**EXHIBIT NO. 1  
APPLICATION NO.  
A-6-PSD-09-43  
Land Use Map**

EXHIBIT NO. 2
APPLICATION NO.
<b>A-6-PSD-09-43</b>
Figure 5.3 of NEVP
Incorp'd by Ref. Into PMP
California Coastal Commission

Location Map: NEVP Phase 1 Coastal Access Features Project

**Project:** North Embarcadero Visionary Plan, Phase 1 Coastal Access Features Project  
**Location:** North Harbor Drive between Ash Street and F Street and West Broadway from North Harbor Drive to Pacific Highway, San Diego, California.  
**Date:** July 8, 2009

Exhibit CCC-4 Proposed Project Landscape and Hardscape features

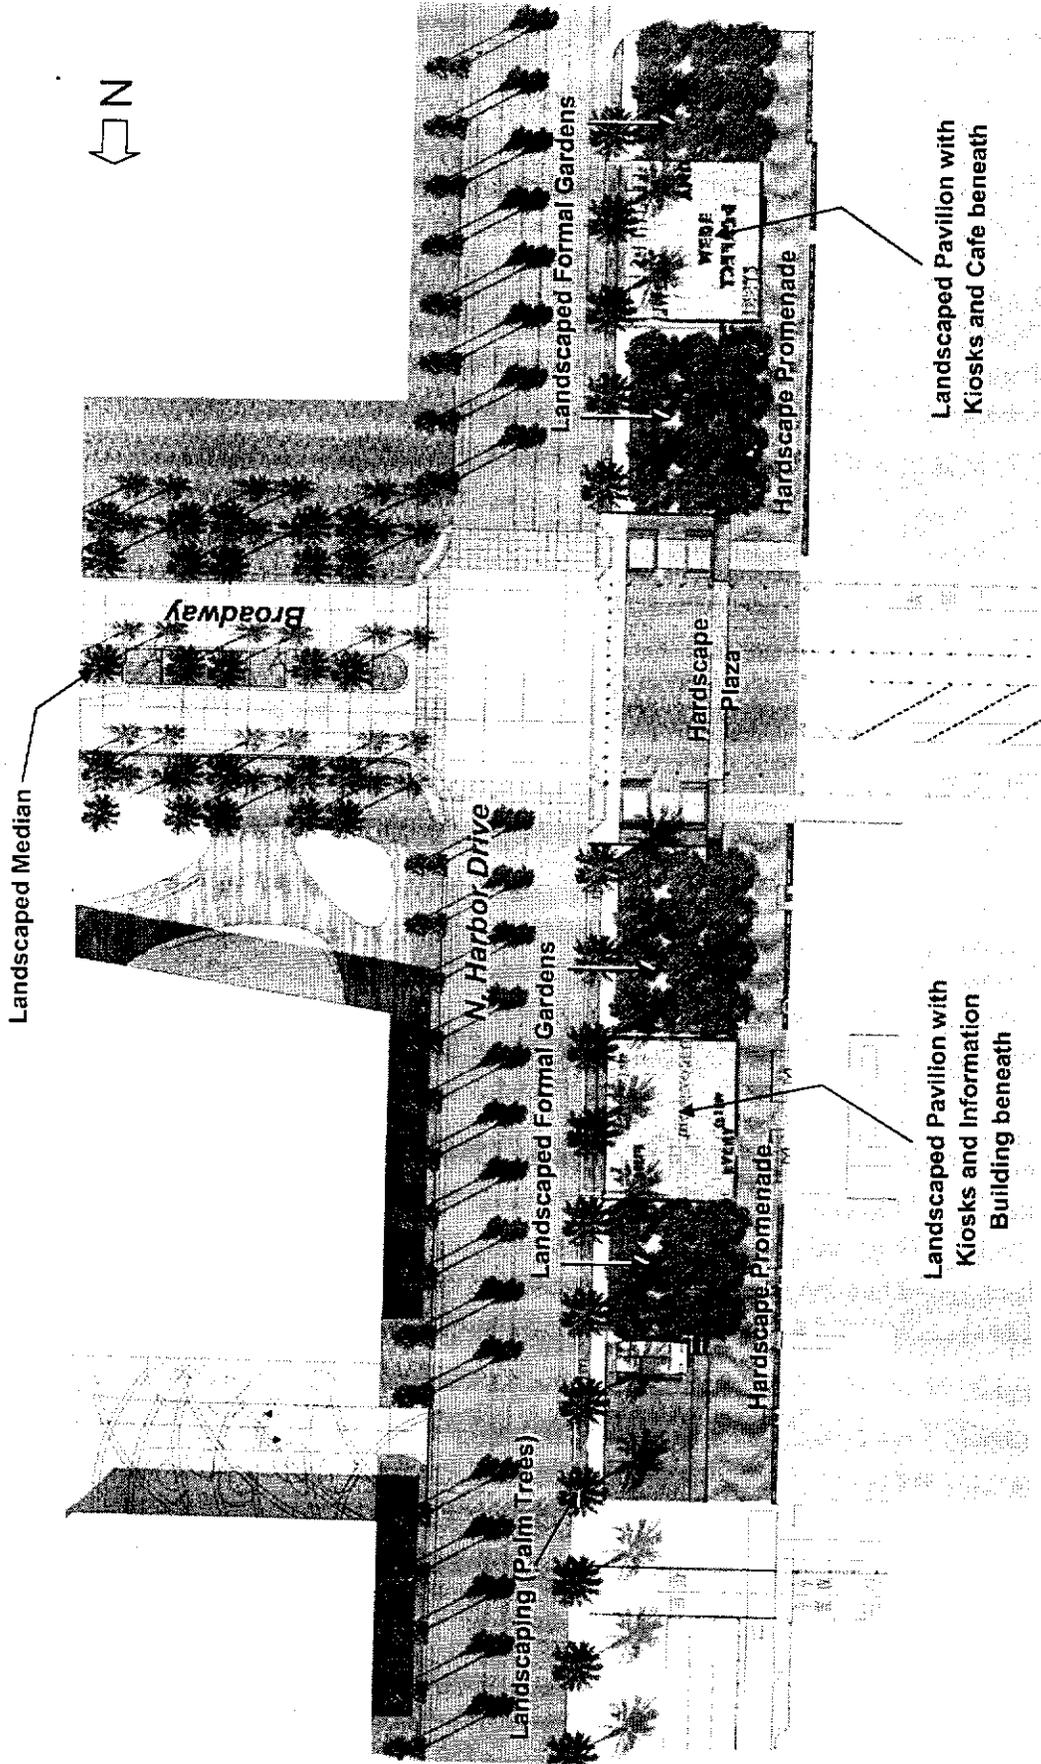
**CCC.10. The commenter requests more information or exhibits that show the Esplanade improvements north of C Street, grassy areas, hardscape, green space, and the plazas at B Street and Broadway piers.** There are no Esplanade improvements proposed north of C Street. Improvements north of C Street involve only the transition between existing and proposed alignments of North Harbor Drive. In response to this comment, the District provided an exhibit to the commenter that further clarifies the project components (Exhibit CCC-3 below). The Proposed Project does not include any 'grassy' areas and no such description is provided in the Port Master Plan. The proposed project does propose 'formal gardens' as described on page 4 of the Initial Study/Addendum "formal gardens on the north and south sides of the open space plaza located at the foot of Broadway", which is consistent with the "passive green spaces (parks) are proposed between the plazas on the esplanade" language on page 63 of the Port Master Plan. In response to this comment an exhibit has been provided to the commenter that identifies the different landscape and hardscape features of the Proposed Project (Exhibit CCC-4 below). The Initial Study/Addendum contains Figure 4 and describes the plaza at the foot of Broadway on page 7 identifying an approximately 16,000 square feet open space plaza on the 107-foot wide Esplanade between the head of Broadway Pier and the intersection of West Broadway and North Harbor Drive. The 16,000 square-foot plaza area at the foot of Broadway will be clear of obstacles suitable for public gatherings, when cruise ships are not berthed at the Broadway Pier. Moveable bollards can be arranged to allow vehicular access to Broadway pier and safe crossing for pedestrians during cruise ship berths, or arranged to prevent vehicular traffic accessing the plaza leaving it clear for pedestrians when cruise ships are not berthed at the Broadway Pier. The public plaza at the foot of Broadway Pier will compliment the plaza area available on the Broadway Pier itself (400-foot from the foot of the pier to the Cruise Ship Terminal Building) when cruise ships are not berthed at the Broadway Pier. The plaza at the foot of B Street Pier is not proposed as part of this project.

- CCC10 Figure 7 of the addendum shows the proposed esplanade improvements from south of Broadway to C Street, but there are no exhibits showing the proposed improvements north of C Street, and this information needs to be included. The addendum should clearly indicate what areas will be hardscape and what will be green space, and if no open grassy areas are proposed as described in the existing PMP, this should be explained. More details on the plazas at the B Street Pier and Broadway, defining landscaped and hardscaped areas, public amenities, etc., must be provided.

<p>B-R-G BRG CONSULTING, INC.</p>	<p>North: Embarcadero Alliance Visionary Plan MEIR</p> <p><b>Proposed Cruise Ship Terminal Expansion Site Plan</b></p>	<p><b>FIGURE</b></p> <p><b>3.3-16</b></p>
---	--	---

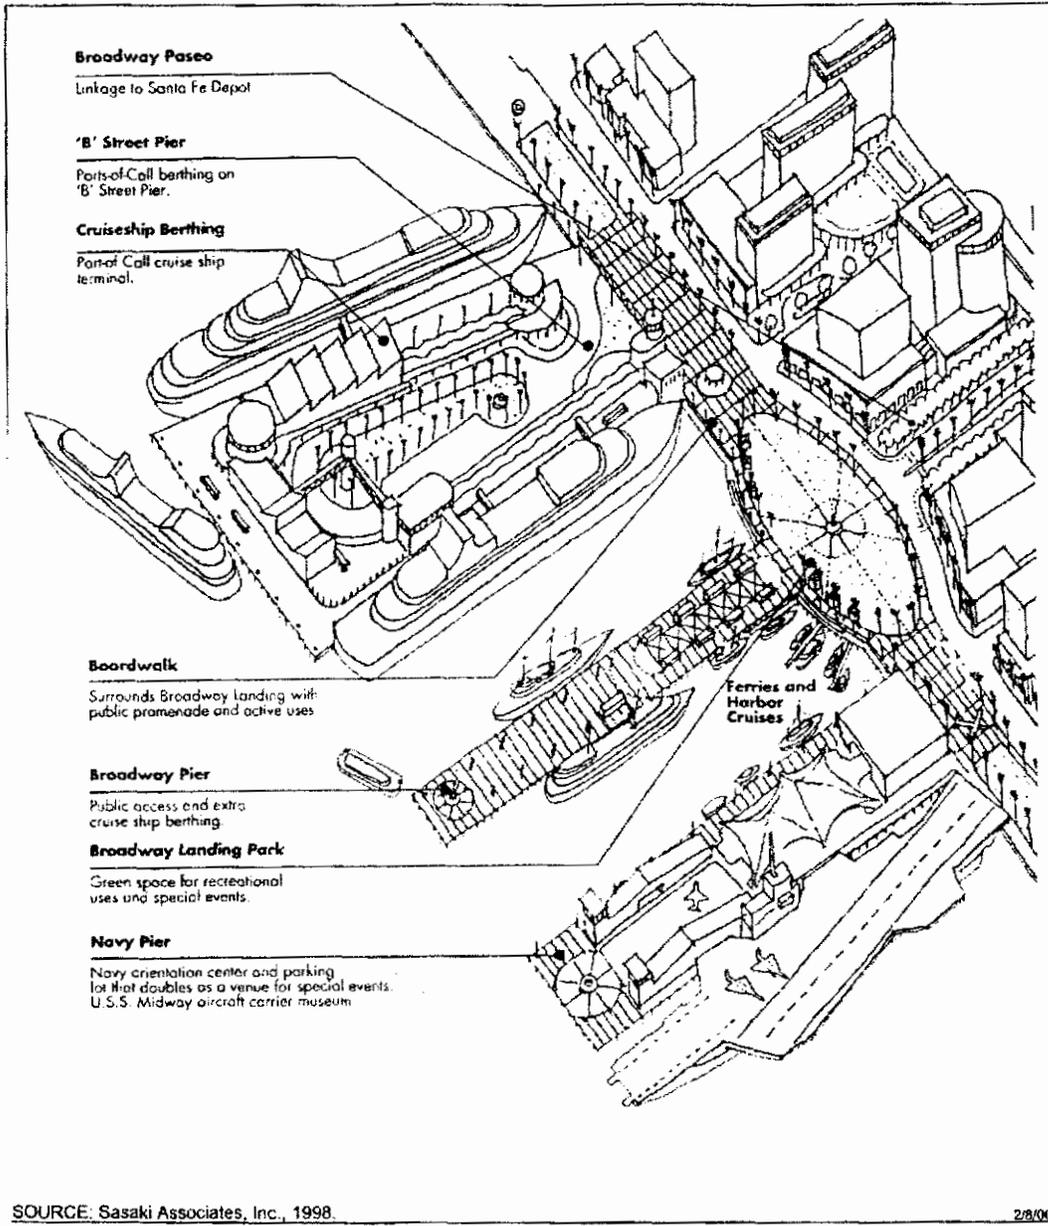
Figure 3.3-16 Broadway Landing Park would provide for a 16,000 square foot oval landscaped park at the foot of Broadway, while the Broadway Pier would be preserved for public gathering and occasional overflow cruise ship berthing. While there was some footnote language in the MEIR regarding FARs related to the pier, and discussion of putting up and taking down temporary tent structures when overflow cruise ship traffic necessitated use of the Broadway Pier for temporary berthing, no party in the NEVP development effort ever brought up the idea of constructing a permanent cruise ship terminal on the Broadway Pier when the original NEVP plan was developed or the 2000 MEIR was developed, reviewed and approved.

The 2000 NEVP MEIR was based on a number of rendering and schematics, which showed the Broadway Pier as an open public community gathering plaza area at the foot of the ceremonial Broadway Hall corridor. Colored pavers would extend down Broadway onto the Pier, where public celebrations and events were planned to take place.

A key concept of the 2000 NEVP concept was that Broadway Pier would provide public views and access to the bay, without any physical or visual obstructions. As noted in Figure 3.3-16 Broadway Landing Park would provide for a 16,000 square foot oval landscaped park at the foot of Broadway, while the Broadway Pier would be preserved for public gathering and occasional overflow cruise ship berthing. While there was some footnote language in the MEIR regarding FARs related to the pier, and discussion of putting up and taking down temporary tent structures when overflow cruise ship traffic necessitated use of the Broadway Pier for temporary berthing, no party in the NEVP development effort ever brought up the idea of constructing a permanent cruise ship terminal on the Broadway Pier when the original NEVP plan was developed or the 2000 MEIR was developed, reviewed and approved.

The Broadway Plaza has not been eliminated. As described on pages v, vii, ix, 4, 5, 7 and shown on Figure 7 of the Addendum / Initial Study the Broadway Plaza is proposed consistent with the envisioned in the NEVP, evaluated in the Master EIR, and described in the Port Master Plan. The rationale for the Addendum highlights the configuration changes to the Broadway Plaza compared to that evaluated in the Master EIR and described in the Port Master Plan as one the reasons making an Addendum to the Master EIR necessary. The changes described would not result in any project-specific significant adverse impacts not previously evaluated in the Master EIR as established by the Initial Study.

The Broadway Plaza is not described as a mitigation measure in the Master EIR. The Broadway Plaza has not been eliminated. As described on pages v, vii, ix, 4, 5, 7 and shown on Figure 7 of the Addendum and Initial Study the Broadway Plaza is proposed consistent with the envisioned in the NEVP, evaluated in the Master EIR, and described in the Port Master Plan. The rationale for the Addendum highlights the configuration changes to the Broadway Plaza compared to that evaluated in the Master EIR and described in the Port Master Plan as one the reasons making an Addendum to the Master EIR necessary. The changes described would not result in any project-specific significant adverse impacts not previously evaluated in the Master EIR as established by the Initial Study. The realization of a rectangular plaza rather than an oval plaza at the foot the Broadway Pier does not result in a significant adverse effect on the environment. Because there is no impact, there is no nexus for mitigation.
